Re: <u>Paramount Pictures Master Plan project</u>; 5555 W. Melrose Avenue CASE NO. ENV-2011-2460-EIR; State ClearingHouse NO. 2011101035

Supplemental Comments on Paramount Pictures Project ("Project")

CEQA No.: ENV-2011-2460-EIR ("EIR")

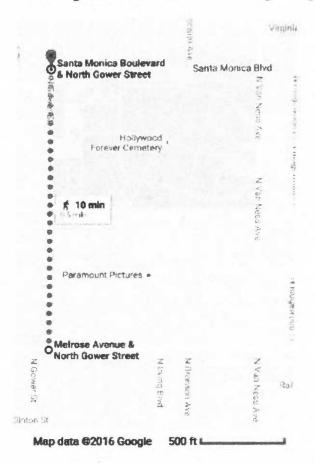
Second, the community remains deeply concerned about transportation impacts that are ignored or underreported in the EIR. This stems at least in part from the intrinsically flawed nature of the transportation study relied on in the EIR. That study ignores what makes this particular Project Site virtually unique in Hollywood and the immediately surrounding areas: there is no east-west

bound public street for at least one-half mile. North of Melrose, between Gower and Van Ness, one has to travel a full half mile to Santa Monica Blvd. before one can cross east-west. The following screenshot comes from Google Maps:

Nowhere does the transportation study adjust its presumptions or methods of calculations, let alone the final tallies of vehicle trips and other projections, to reflect this extraordinary situation.
